Brent Decommissioning Derogation: An evaluation

**The Ministry of Infrastructure and Water Management
Government of The Netherlands**

an independent evaluation group

4 October 2019

Page 22: Figure 7 shows the general arrangement of drawdown system and the piping system that goes into the cells (see also Figure 10).

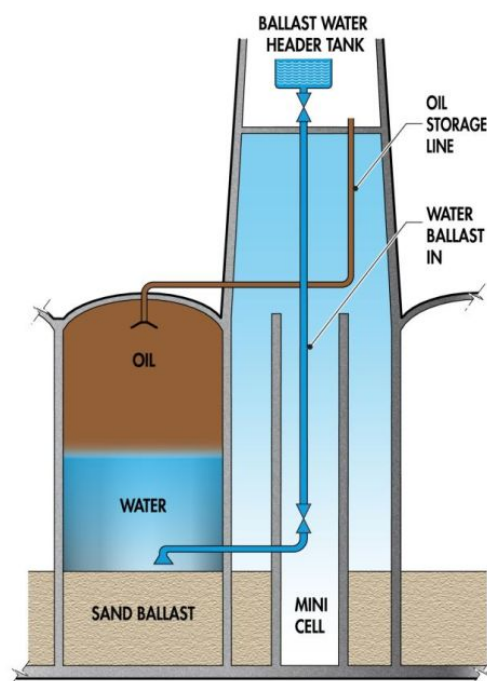
Page 88: From the report by Aker Kvaerner that studies the existing pipework of the GBS cells, it is found that:

- *“The pipework is in place and accessible via the utility leg”*
- *“There are existing operational procedures and experiences for working down the utility leg”* that can *“reduce the amount of subsea activities required”*.
- The disadvantages are the risk of H₂S poisoning if personnel work down the utility leg, equipment cannot be deployed via the pipelines, the topside needs to be in place to break into the pipework from a lower level.
- *“The existing pipework could be used to pump fluids to and from the storage cells”*

Page 91: Drilling a large hole into the cell top is technically challenging and associated with major safety risks.

- *“The use of the existing pipework cannot be completely excluded”*
- *“Fluids could be injected inside the storage cells via the existing pipework”*
- Injected fluid might flow into other cells as well.

- *“Fluids could also be displaced through the water ballast system using the produced water pumps”* with some modifications since these are not designed for this purpose.

- The extraction system is designed to pump only hydrocarbons (with a lower density than water). For the extraction of other fluids, the pumps need to be replaced.

- *“The existing pipework is in a poor or unknown condition. It cannot be used as it is to support remediation activities. Modification and reinstatement would be required to make it suitable for use”*. This statement is in direct contradiction with several other statements about the possibility of using the piping system for pumping fluids. Also, these modifications were never considered as an option.

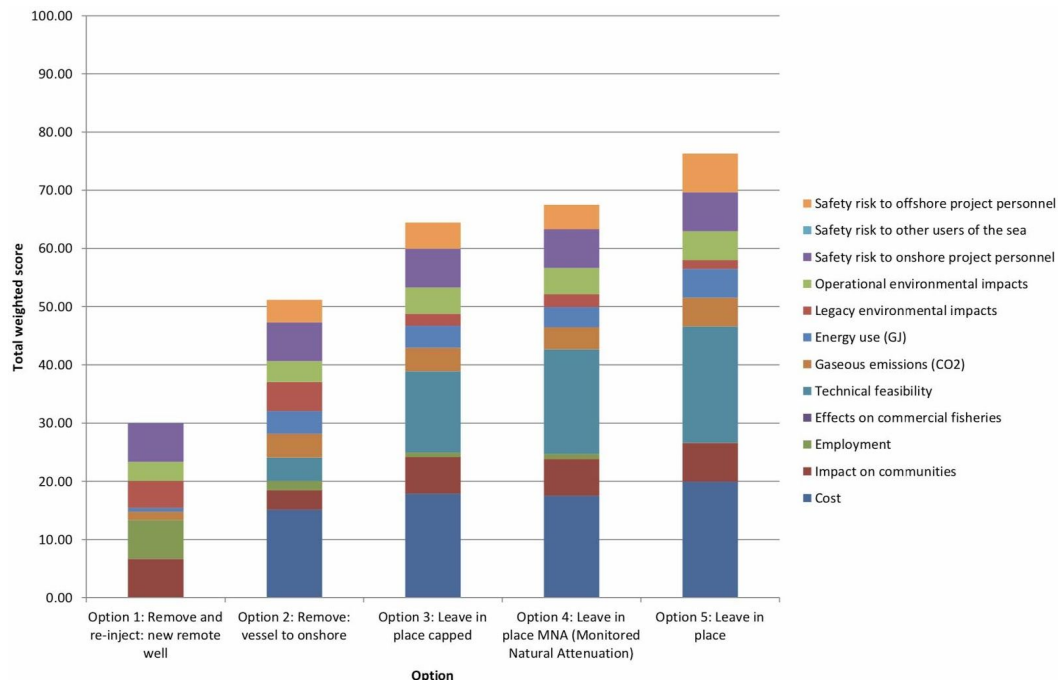
“On the basis of this assessment, the ‘CA-recommended option’ for the Brent Delta cell contents is Option 5 ‘Leave in Place’.”

“In all six of the scenarios, the order of the five options does not change as a result of the changes in weighting. Option 5 ‘Leave in place’ always has a higher total weighted score than the next best option”
